Design and Access Statement
for
The alterations to the apartment scheme at Victoria Mill,
Miles Platting, Greater Manchester

AllisonPike
Architects and Designers

This design and access statement is submitted in support of applications for key changes to the previously approved apartment scheme for Victoria Mill (application number 119321/JO/2018 submitted by Signature Victoria Mill part of Signature Living).

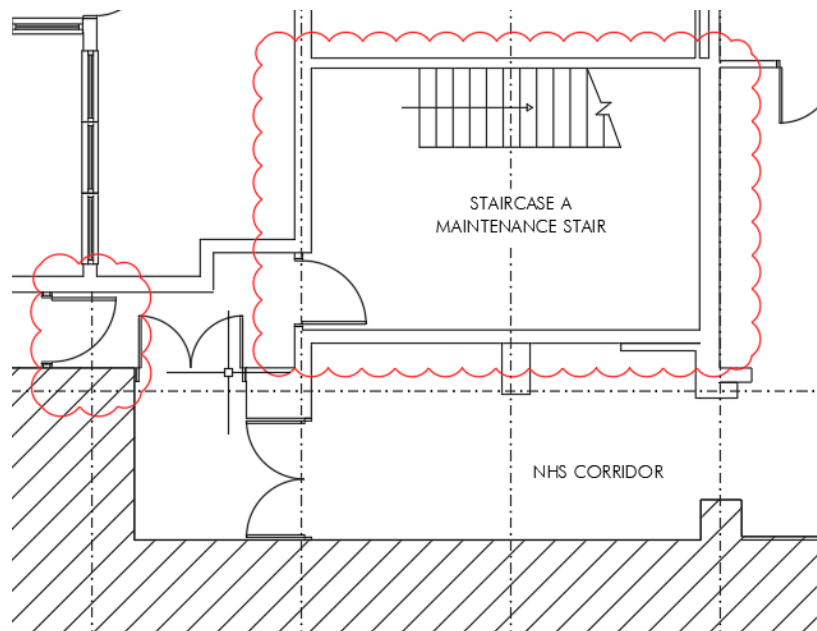
The original scheme housed cycle storage in the existing basement. This was to be accessed by a long ramp and narrow internal corridor. This was viewed to not be very convenient for residents and therefore not be used.

Following discussions with our Secure by Design consultant it was agreed that the best solution to encourage cycle usage was the inclusion of cycle stores on each floor of the building in one of the existing storerooms.

- Secure external cycle storage within the building behind several access-controlled doors
- Cycles can be stored close to residents accommodation

Extract of the ground floor plan showing the addition of a door (highlighted in red revision cloud)

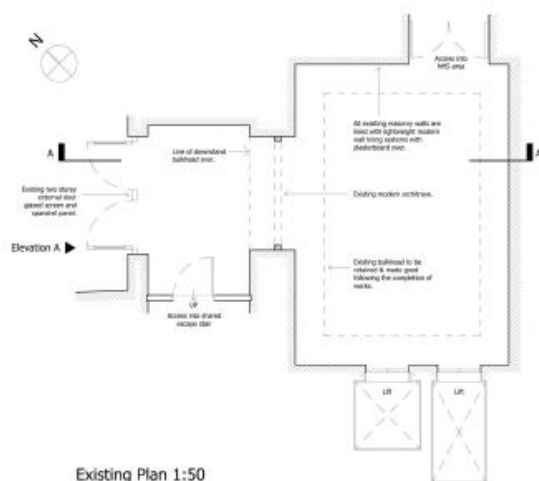
The existing building has three staircases. One of the alterations to the scheme is to change staircase A from an accommodation stair into a maintenance stair. The reason for omitting this staircase as an escape route for the residents is that at ground floor the escape route from the staircase would merge with the escape route from the ground floor offices which is in contravention of building regulations part B. An additional door has also been added in the NHS corridor to comply with building regulations, see the following drawing extract, this is to provide a two separate escape routes for maintenance staff from stair A.

Existing Plan 1:50

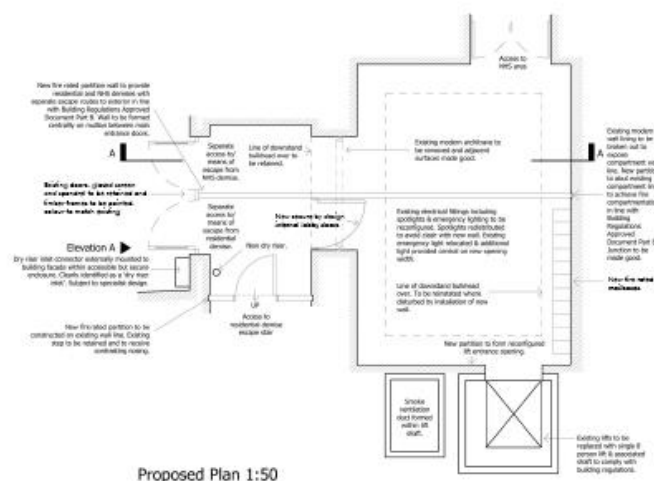
In the original scheme the escape route from the apartments merged with the escape route from the offices in the ground floor lobby of staircase C. In order to comply with the requirements of Part B of the Approved Building Regulations (Fire Safety) each use needs to have a separate escape route.

In order to provide this a dividing wall is required in the ground floor lobby of staircase C, as shown in the following drawings:

Original lobby arrangement in the planning approved scheme

Proposed building regulation compliant lobby arrangement

This is a necessary change to comply with building regulations Part B.

Location of smoke vent for staircase C

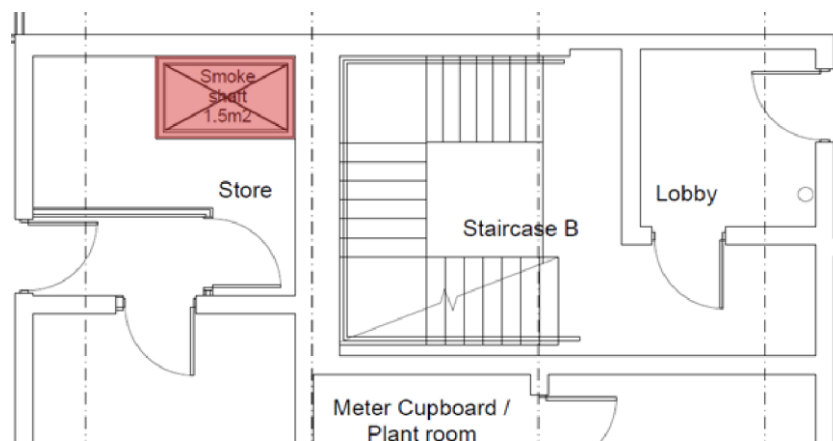
To comply with this building regulation requirement two smoke vents need to be incorporated into the scheme, one to protect each stair. The project's fire strategy document provided by BB7 outlines the ideal location of the smoke shafts as follows; '*the smoke shaft should be located at the remote end of the corridor away from the staircase*'. When considering the location of the shafts the impact on the fabric of the listed building was carefully considered. For the vent to staircase B locating the vent in the redundant staircase A was considered first however, this location proved to be unworkable because the shaft cannot have any bends in it and due to the location of staircase A in relation to staircase B this fundamental criteria for the shaft would not be met. The remaining area of the core of the building has brick jack arch ceilings and therefore wherever in the core it was to be located an opening in the brickwork would be required. So we have located the shaft in the store room adjacent to the protected corridor to staircase B which complies with the requirements of the British standard. The shaft for staircase C is located one in the disused lift shafts next to the new firefighting lift. This is an existing shaft and does not require any new openings through the floor, only one opening at roof level. The following drawings show the location of the shafts:

Locating the smoke vent for staircase C in the disused lift shaft will have minimal impact on the fabric of the listed building. To create the opening for the smoke vent for staircase B openings will need to be formed in the jack arch brick floor construction at each level. This smoke vent is required in order to make the building safe for a residential use. So whilst installing this shaft will result in some harm to the listed fabric the building as a whole will be protected and maintained long term by full time occupation.

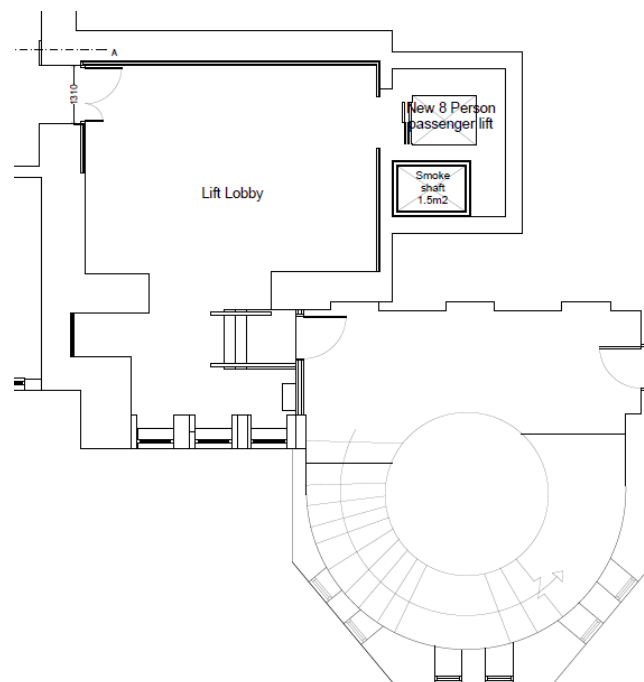
This clearly states that it is not acceptable to have a refuse chute in a staircase (even though staircase A is now a maintenance stair) which links to an escape route on the ground floor.

To comply with building regulations the solution is to locate a bin store on each floor within the central core; this has now been included in the design, see the refuse drawing that accompanies this application. Another building regulation requirement of the bin stores (as listed in the above extract) is that they have permanent ventilation. This will be provided by ductwork going vertically between each bin store; this will require openings in the brick jack arch floors, but is a necessary inclusion in

Extract from the third floor GA plan showing the small flight of steps required to link the lift lobby and staircase C

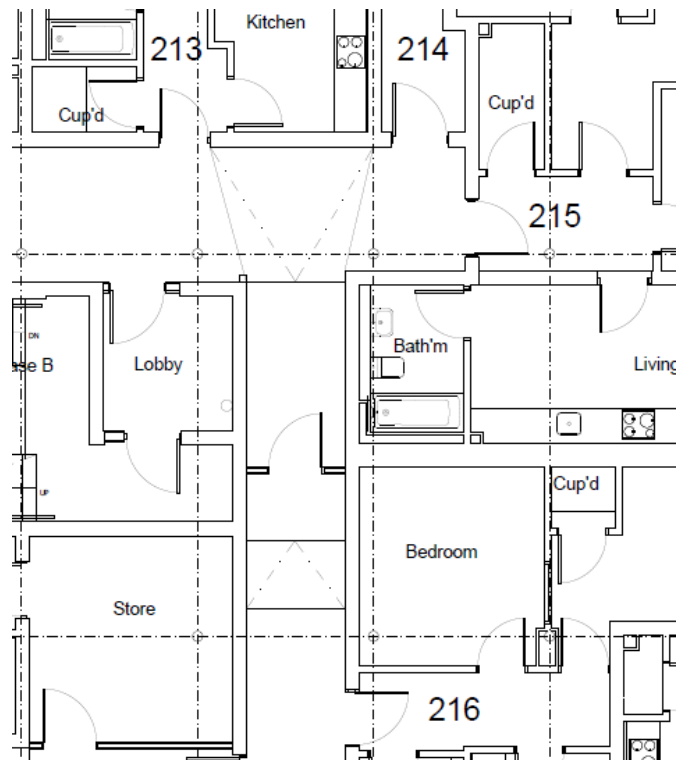
Since starting the construction work it has become necessary to include some additional steps and a ramp to overcome differences in floor levels. At second and third floor a small flight of steps is required between staircase C and the lift lobby, as the following drawing shows:

Typical general arrangement plan with building regulations diagrams above and the required cross corridor door referenced from the building regulation guidance (shown in red),
Diagram provided by BB7 Fire Ltd

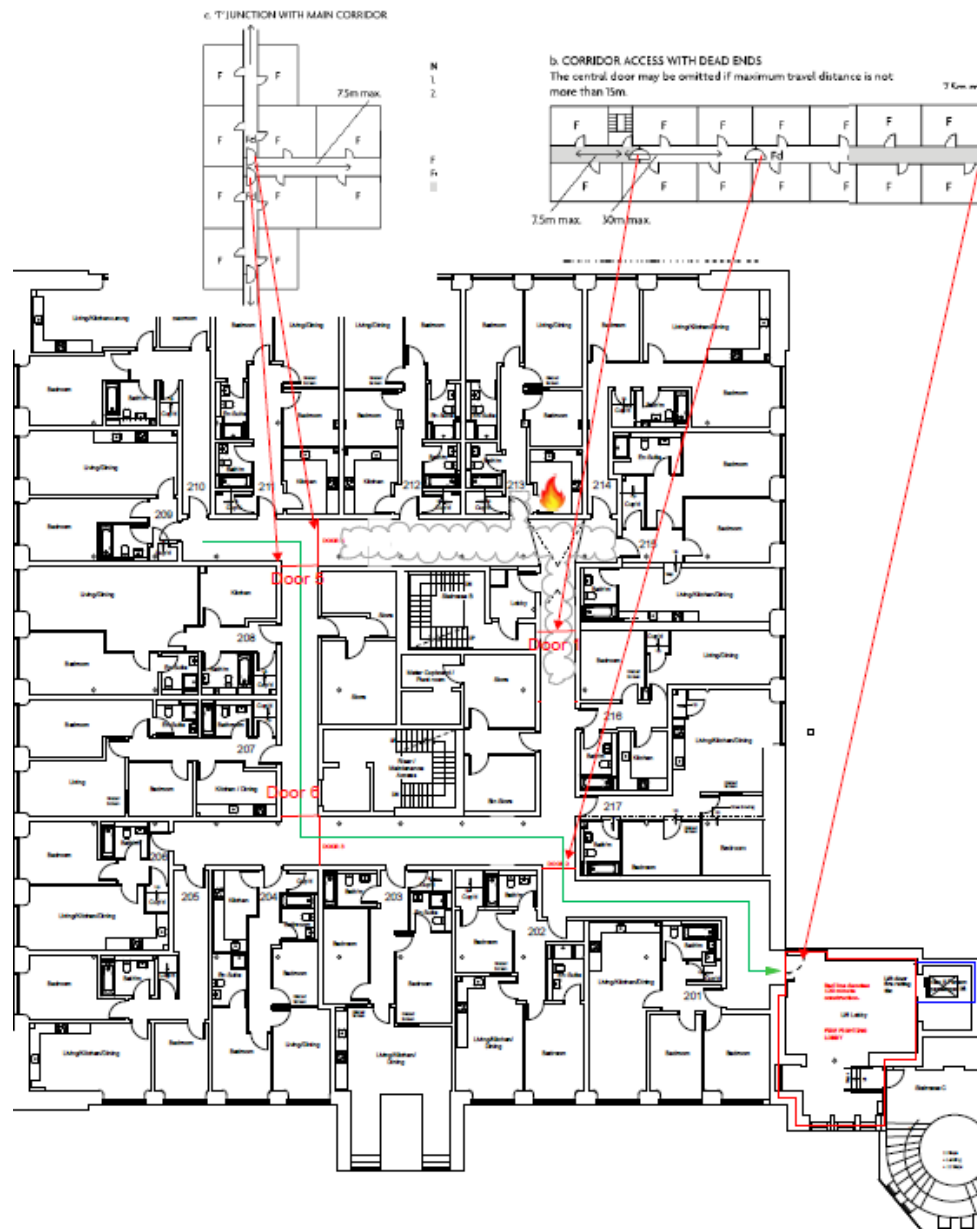
The approved scheme included for two cross corridor doors per floor. The position of these doors were not in accordance with the requirements of Building Regulations Part B Volume 1: Dwellings. There are two dead end corridors in the design and at the end of each one there is a requirement for an alternative protected means of escape. This is described and drawn in both building regulations Part B Volume 1 for Dwellings and the British Standard BS9991:2015. The figure below shows the diagrams from the building regulations referenced to the specific design of Victoria Mill as provided by the project appointed fire engineer BB7 Fire Limited. This is a necessary change in order to use this building for a residential purpose.

Extract of the ground floor plan showing the corridor from staircase B with an additional door added (highlighted in the red revision cloud)

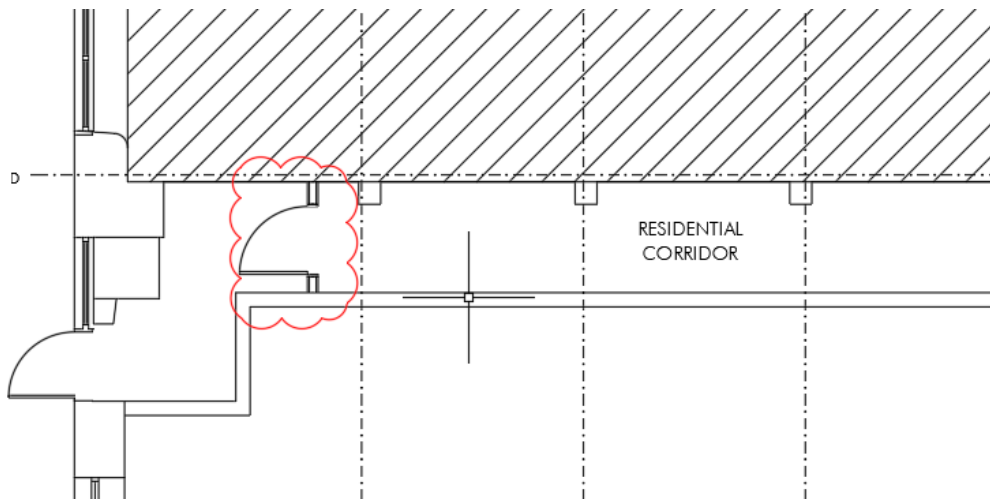
In order to comply with Secure by Design requirements the rear ground floor fire exit door needs to be made secure. The existing external door is listed therefore it was proposed that an additional internal Secure by Design door would be added to comply with this requirement, see the following drawing extract. This has been agreed with the Secure by Design consultant and is required to achieve accreditation.
